UNITED STATES
DEPARTMENT OF THE INTERIOR
BUREAU OF LAND MANAGEMENTFORM APPROVED
OMB NO. 1004-0137
Expires: January 31, 2018**SUNDRY NOTICES AND REPORTS ON WELLS**
*Do not use this form for proposals to drill or to re-enter an abandoned well. Use form 3160-3 (APD) for such proposals.*5. Lease Serial No.
NMSF078903A6. If Indian, Allottee or Tribe Name
EASTERN NAVAJO7. If Unit or CA/Agreement, Name and/or No.
892000844E8. Well Name and No.
GALLEGOS CANYON UNIT 119. API Well No.
30-045-13354-00-S110. Field and Pool or Exploratory Area
UNKNOWN11. County or Parish, State
SAN JUAN COUNTY, NM**SUBMIT IN TRIPLICATE - Other instructions on page 2**

PLUG AND ABANDONMENT PROCEDURE

Gallegos Canyon Unit #11

CONDITIONS OF APPROVAL

Gallegos Canyon Unit #11

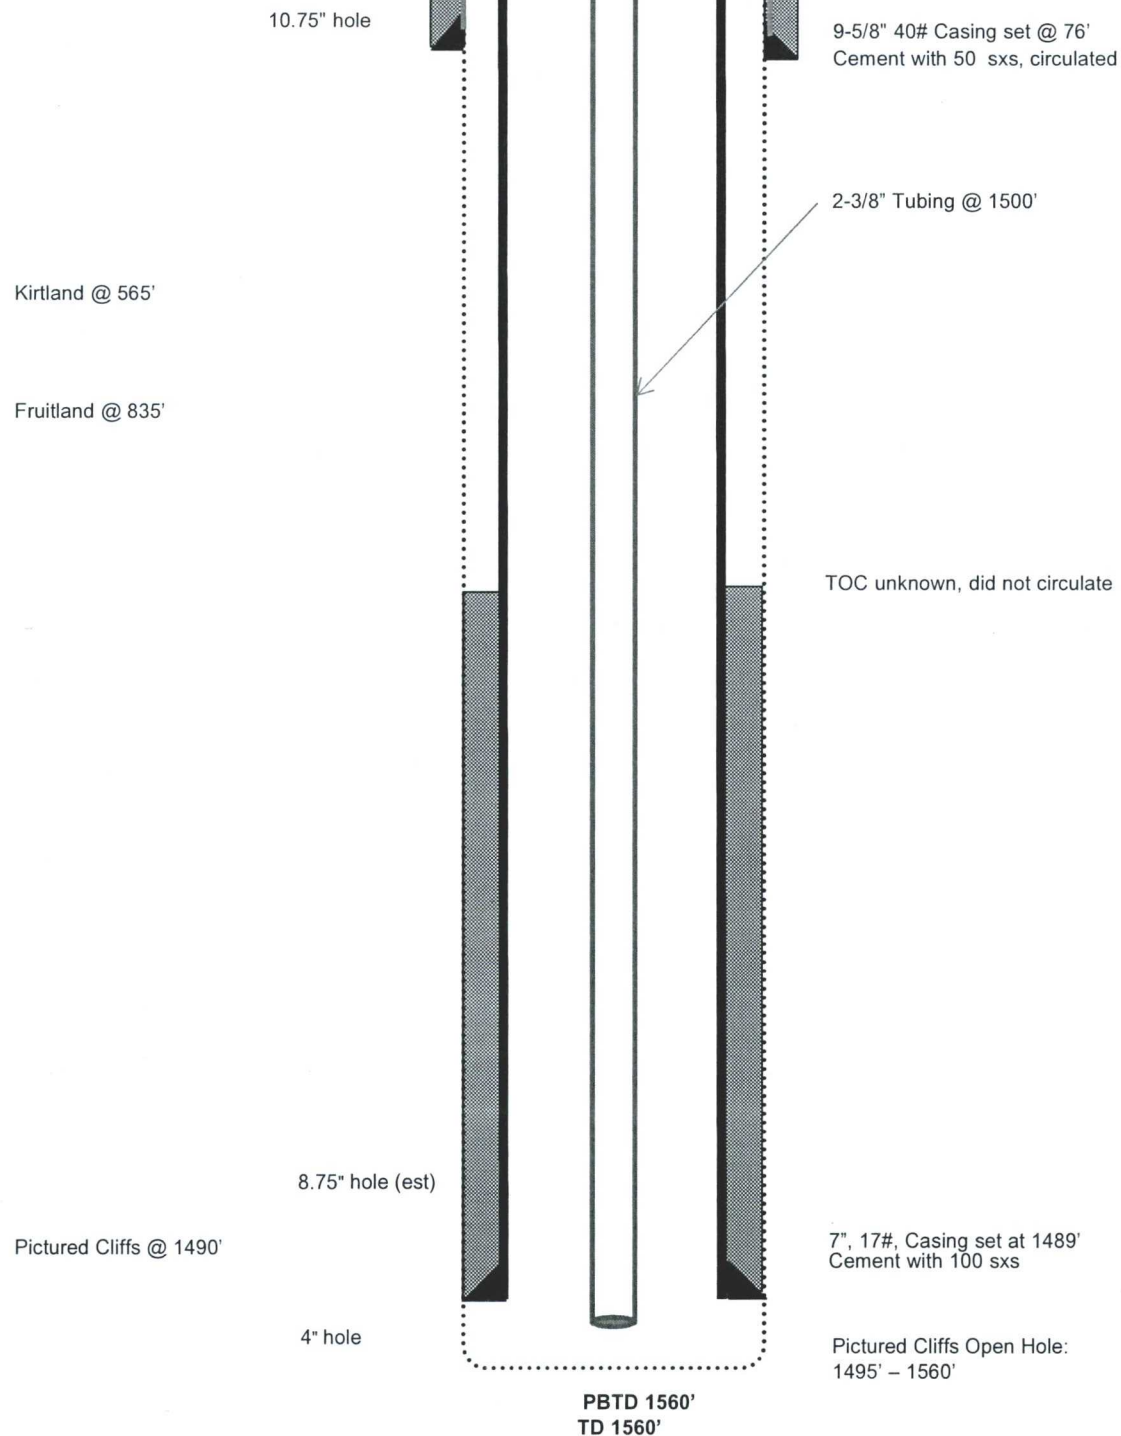
- a) Set Plug #1 (1445 – 1169) ft. to cover the Fruitland top. BLM picks top of Fruitland at 1219 ft.
- b) Set Plug #2 (416 – 218) ft. to cover the Kirtland and Ojo Alamo tops. BLM picks top of Kirtland at 366 ft. BLM picks top of Ojo Alamo at 268 ft.
